ADDENDUM TO THE CONTRACT DOCUMENTS

ADDENDUM No.: 1

DATE : 8/25/15

PROJECT: New Town Hall
Construction Project
26 Court Street
Plymouth, MA

DOWNSPOUT AT WEST ELEVATION

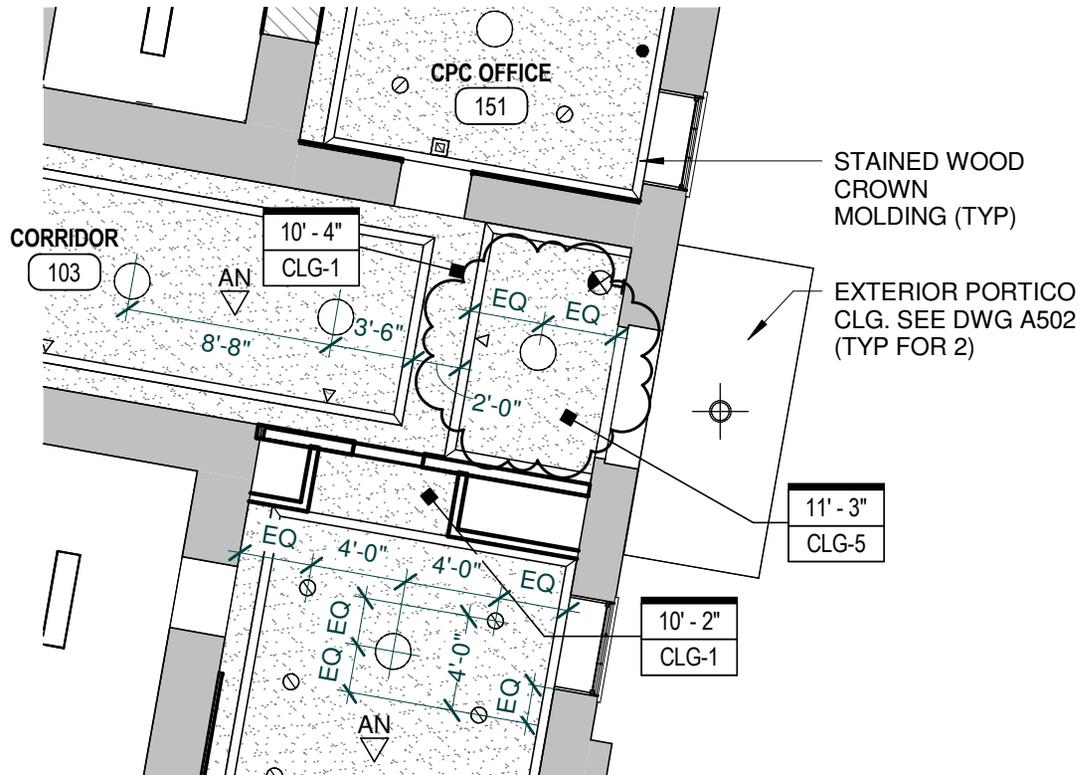
- SKA-001 - "Downspout at West Elevation," dated 8/12/15.
- SKA-002 - "Add Pendant Light in Clg at Door," dated 8/12/15.
- SKA-003 - "Lobby Tile Pattern," dated 8/12/15.
